1. AGENCY USE ONLY (Leave blank)		2. REPORT DATE 14 Dec 90		3. REPORT TYPE AND DATES COVERED Summary Jun-Dec 90	
4. TITLE AND SUBTITLE Technology Insertion (TI)/Industrial Process Improvement (IP) Task Order No. 15 Contract Summary Report/Quick Fix Plan for SA-ALC/MAE & MAT (Gas Turbine Engine)				5. FUNDING NUMBERS Contract

TASK ORDER NO. 15

MDMSC RESPONSE TO HQ AFLC COMMENTS

TASK ORDER NO. 15 MDMSC RESPONSE TO SA-ALC COMMENTS

AVERAGE BACK SHOP FLOW TIMES
FIGURE 8.1.1.4-1

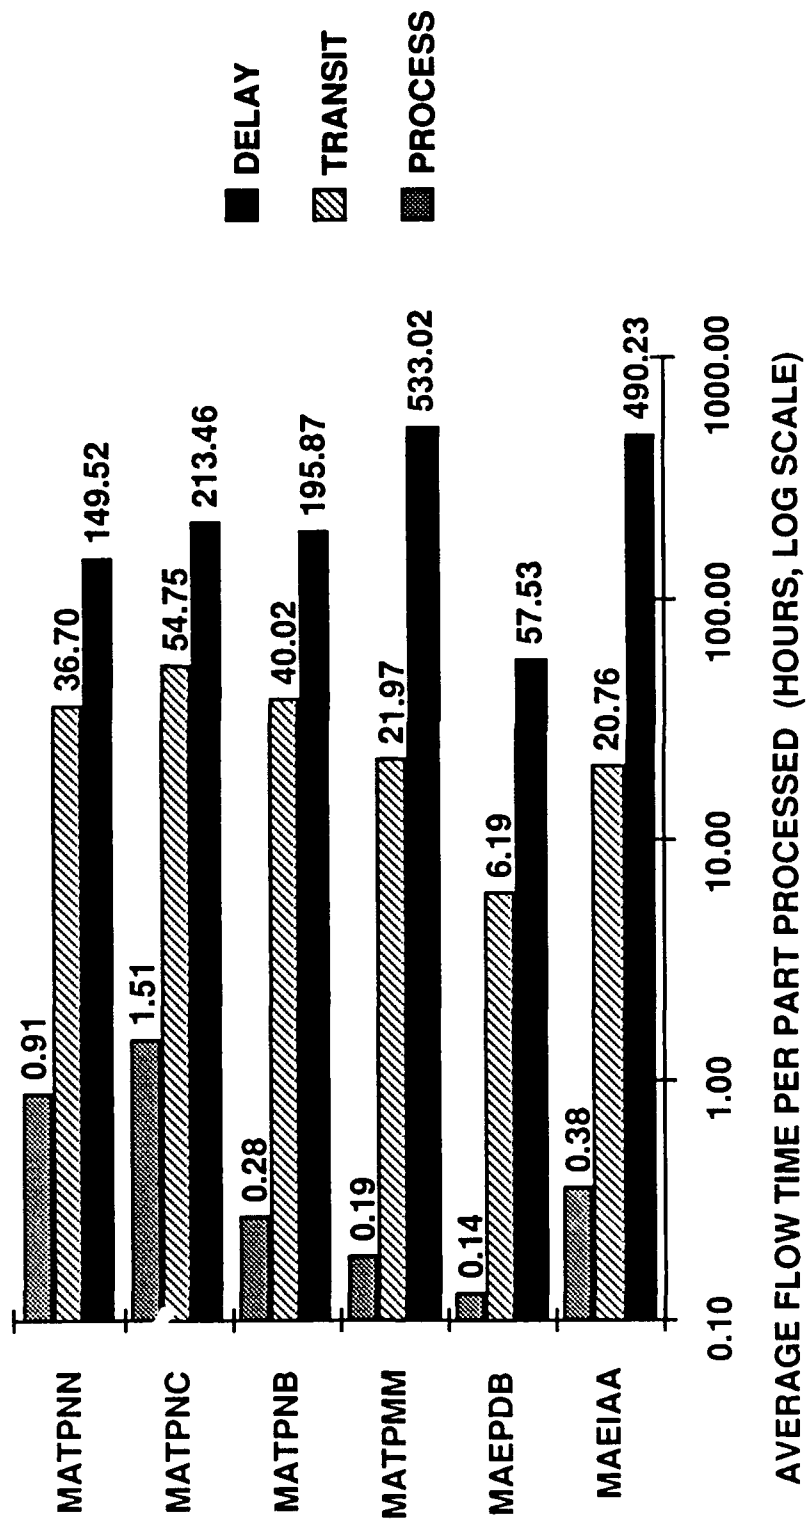
9. Concur - Correction included in REV A CSR.
10. This Data is shown in Figure 8.1-5 of the CSR.
11. Concur - Engines which cannot be repaired in the test cell are rejected and returned to final assembly. The flow time shown across the test cells reflects this.

FIGURE 8.1-1

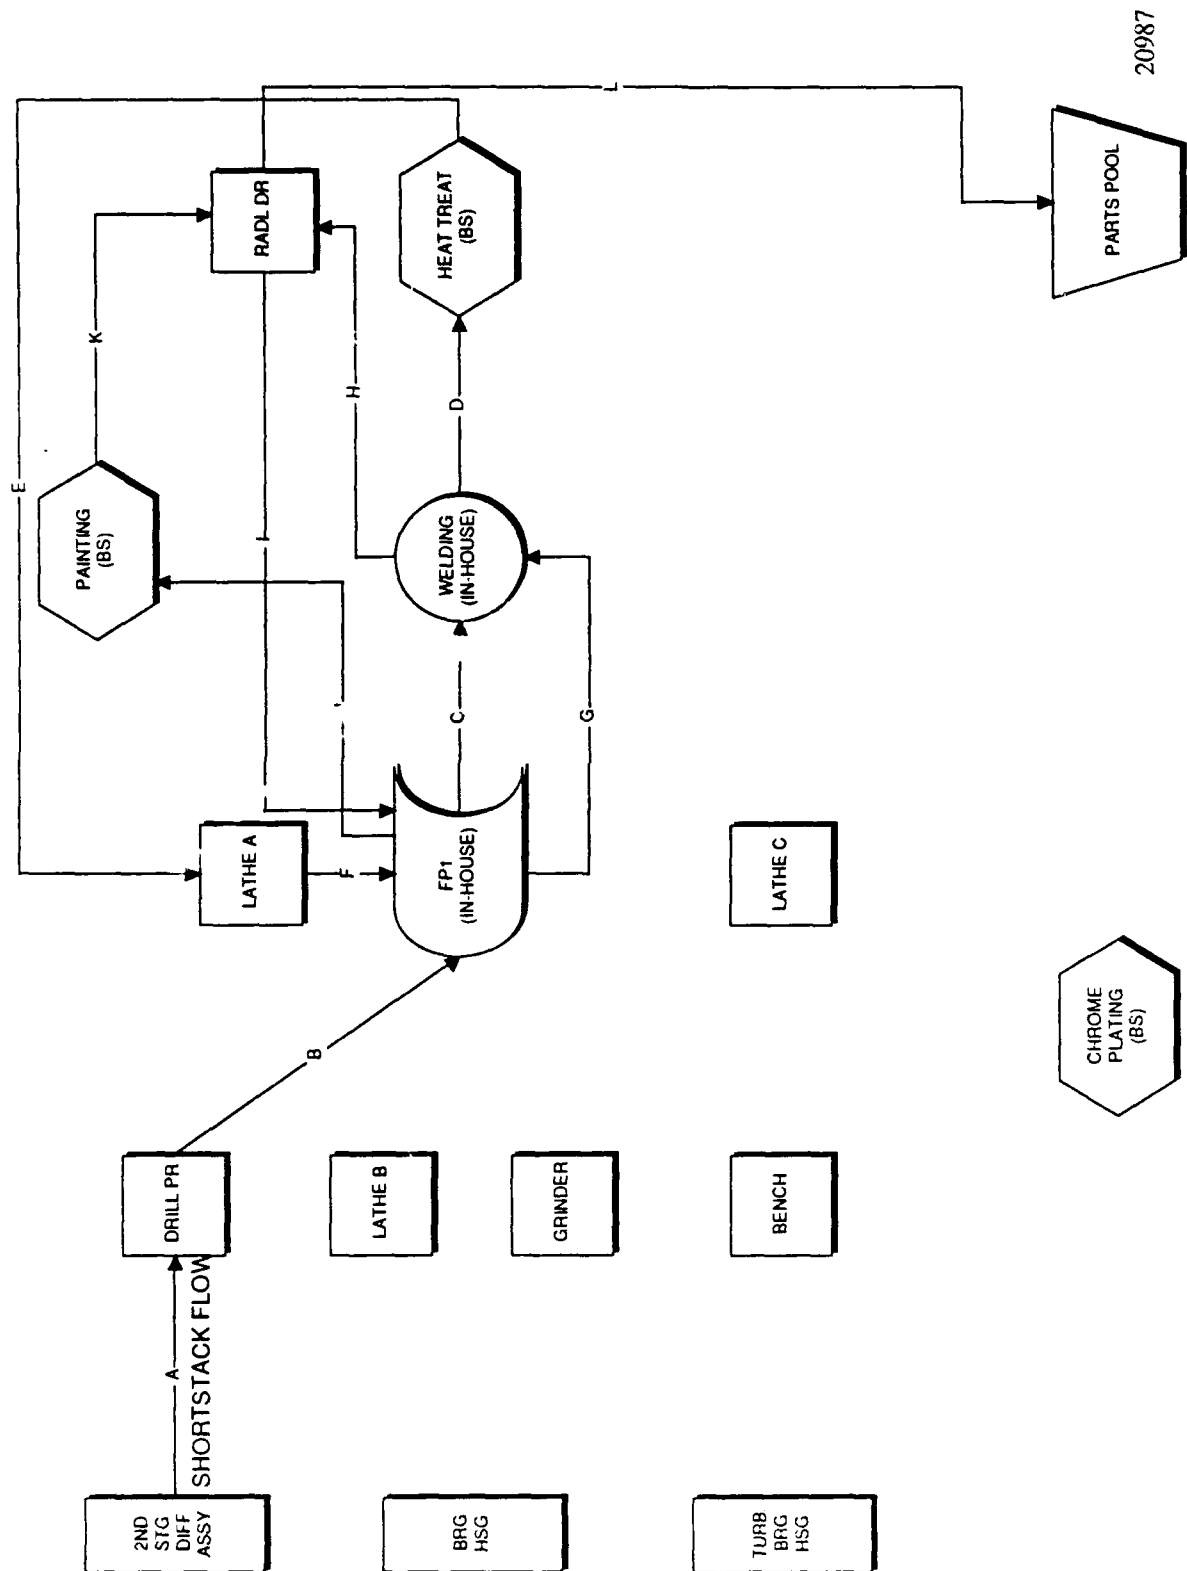
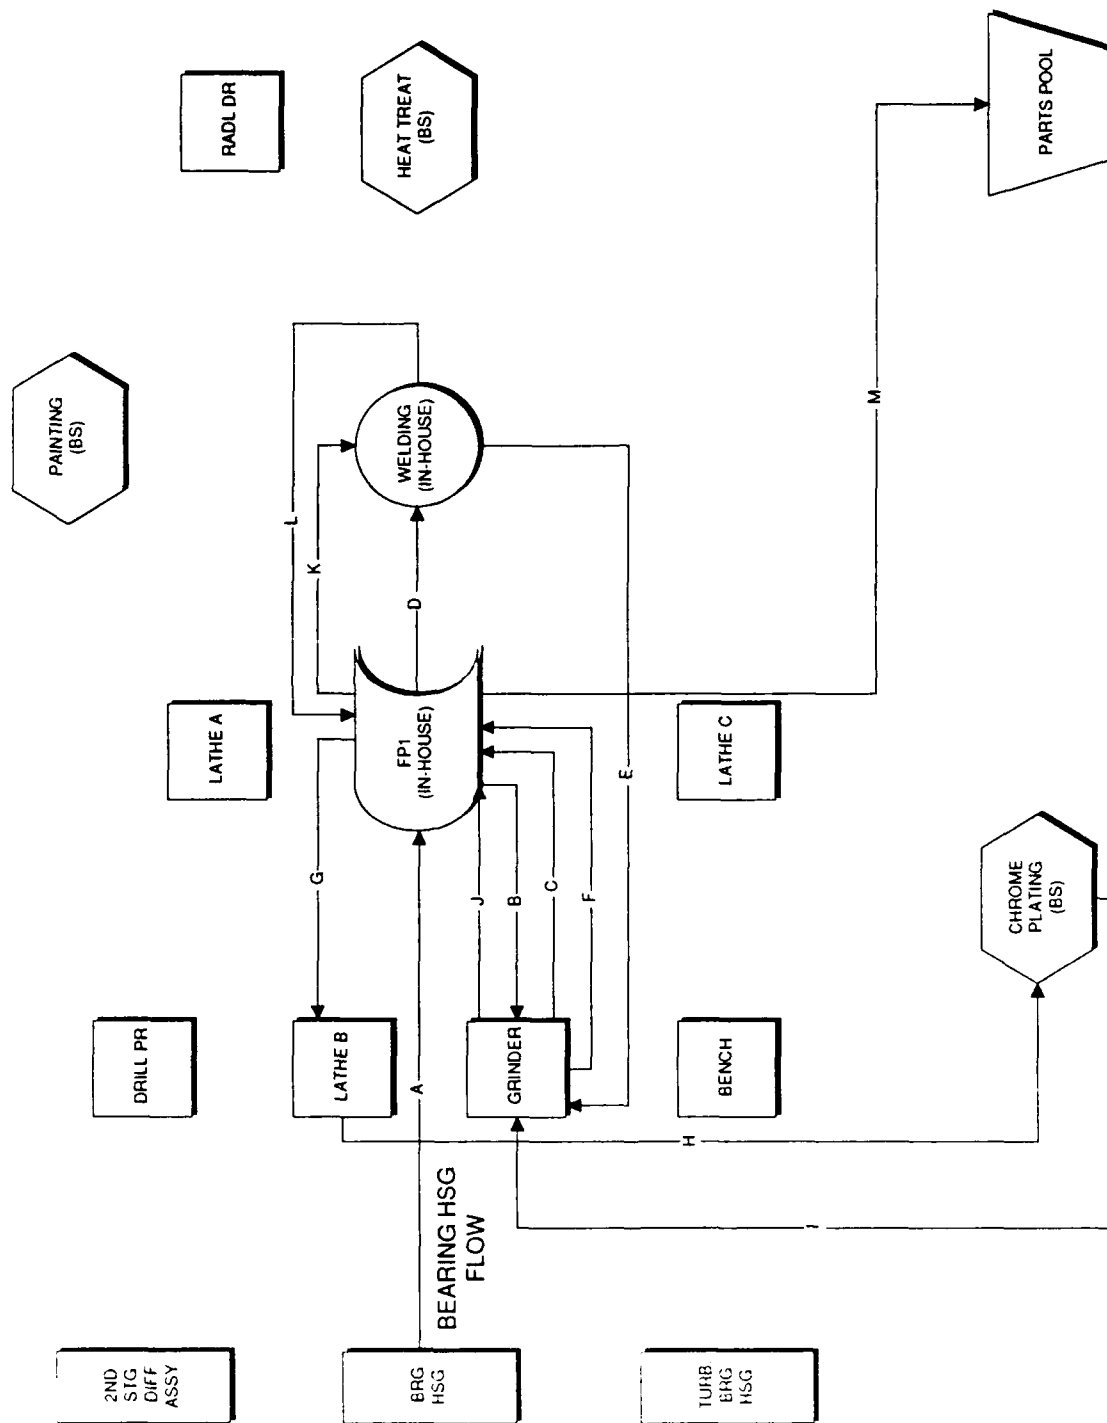
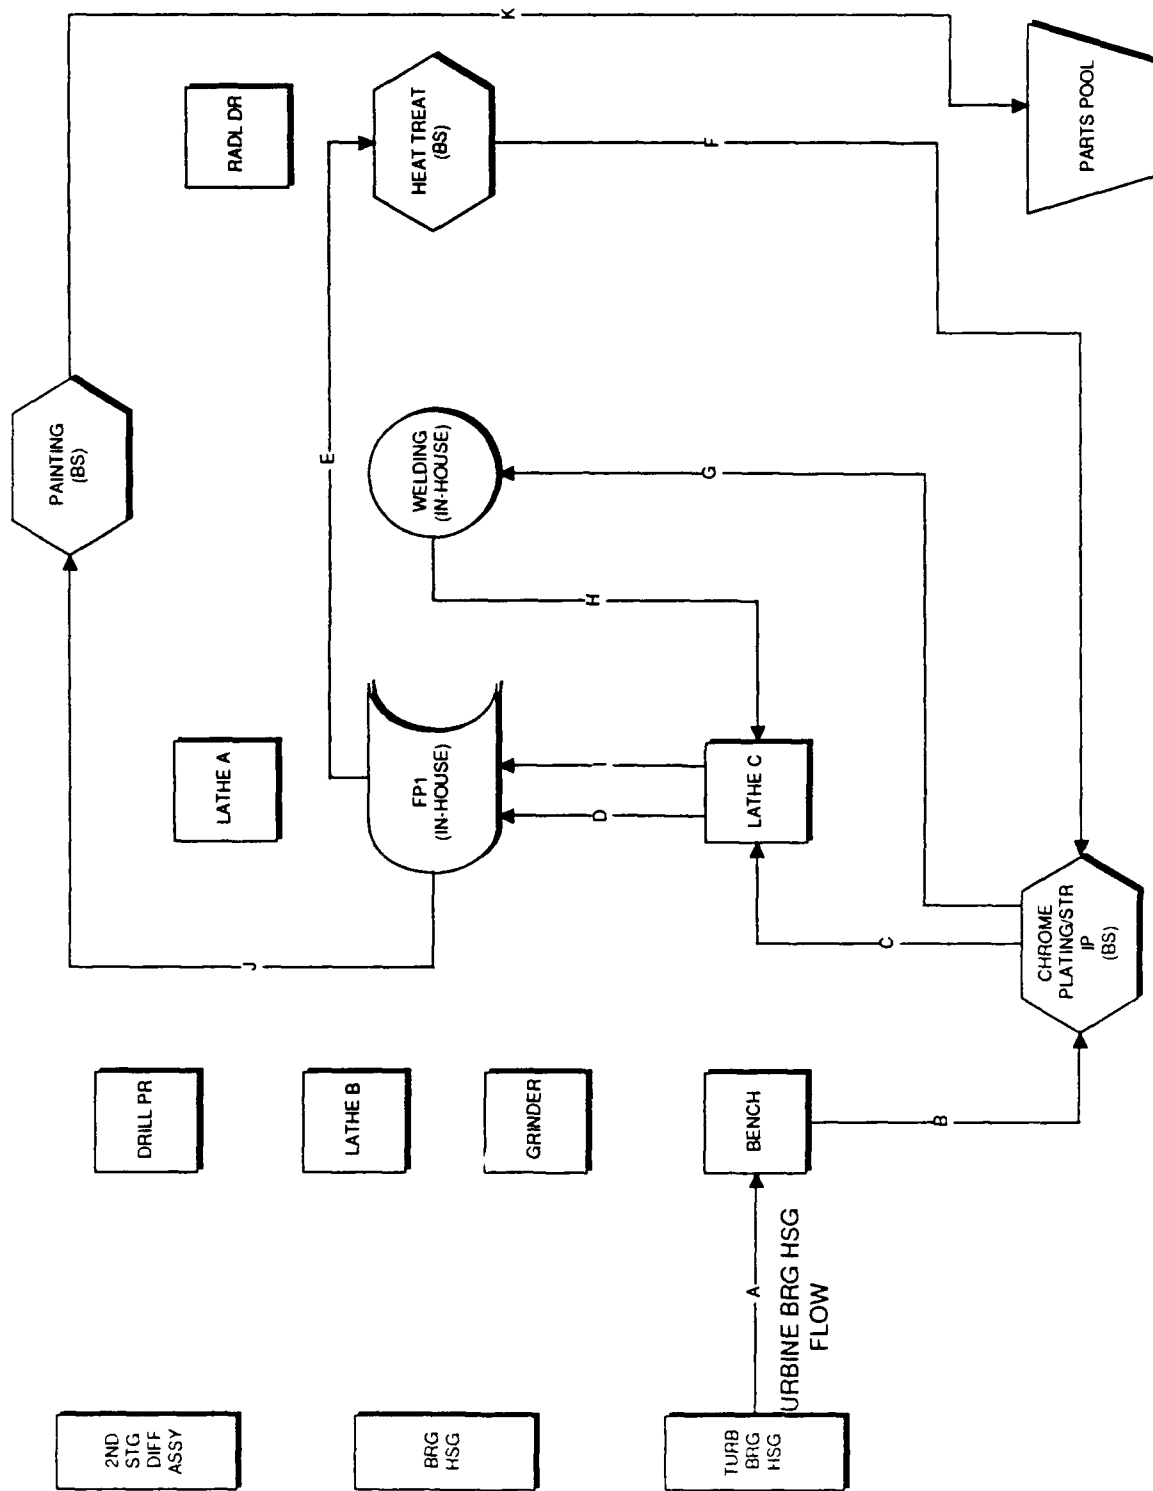
24. MDMSC's analysis indicates that these parts can be processed, on the average, in the times shown on Table 8.1-1 of the QFP. This processing includes the process steps shown on figures 8.1-1 through 8.1-3 (including FPI inspection). Cleaning is not included in these processes. These figures are UDOS 2.0 estimates. The output sheet showing this is page 804, section 8.1 QFP, of the DDB.
